# FINDING OF NO SIGNIFICANT IMPACT FOR

# 17<sup>TH</sup> STREET EXTENSION [GDOT PROJECT NH-7141-00(900), P.I. NUMBER 714190]

# ATLANTIC STEEL REDEVELOPMENT PROJECT FULTON COUNTY, GEORGIA

# SUMMARY OF ENVIRONMENTAL COMMITMENTS

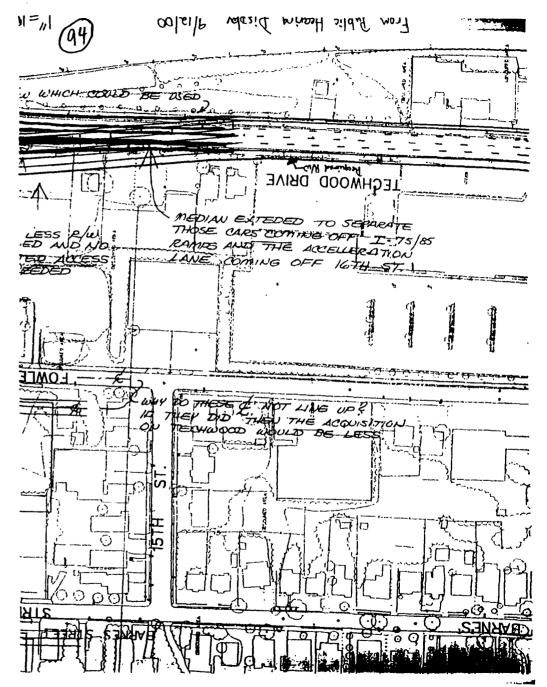
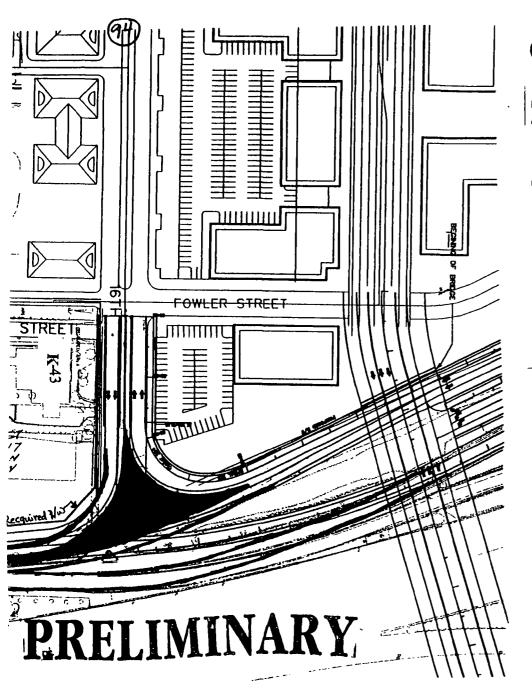
I and other owners do not want to stand in the way of progress, but the progress clamoustrated at the September meeting were extreme and the graphics presented were antoonise" at best with obvious design thous demonstrated:

Derious consideration of my idea would be appreciated and would prevent puture

conflict between the BDOT and the property owners on the west side of technoof drive. The GDOT should be sensitive to owners ideas - sometime they might see things differently and their ideas are not recessarily unprofessional.

Again, slesse reconsider my idea to avoid a dramatic mispact on the properties along the west side of technool Drive.
